# AGRITOPIA

## SIGNAGE CRITERIA

FIRM NAME / PROJECT ADDRESS	
Joe's Farm Grill	
Higley Road & Ray Road	
Gilbert, Arizona	
SALESPERSON	B. Grinstead
ORIGINAL DATE:	2/16/06
ORIG. DESIGNER:	L. den Dulk
SCALE:	As Noted

**60118R3**  
 FILE DESIGN NUMBER

**C ILLUMINATED TOWER DISPLAY**

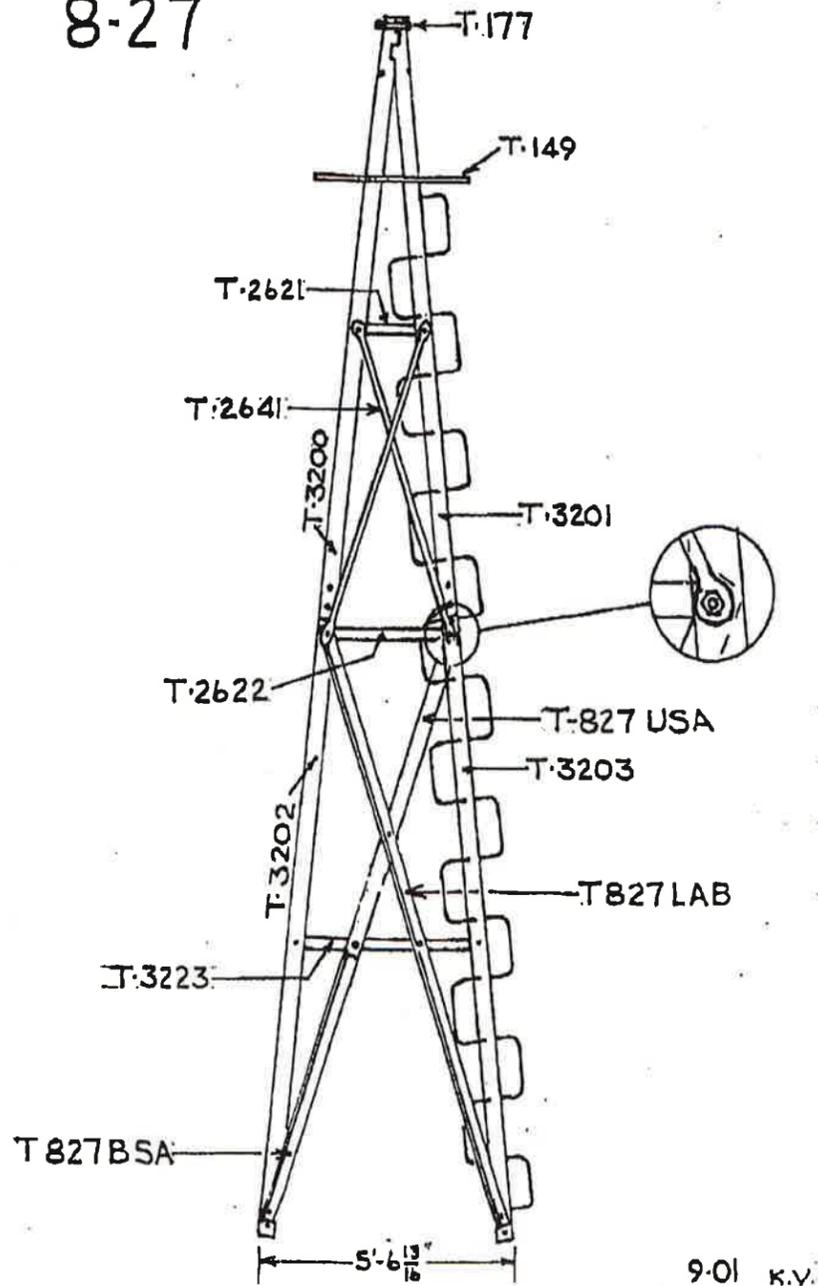
1. "B"... RELAYOUT. "D" RELAYOUT. ADD TOWER DETAILS (SEE SHEET 5).
2. "C"... REDESIGN SIGN. "D"... ALTERNATE DESIGN FOR "C". CHANGE R1 "C" TO "D".
3. DELETE "COFFEE SHOP" SIGN.
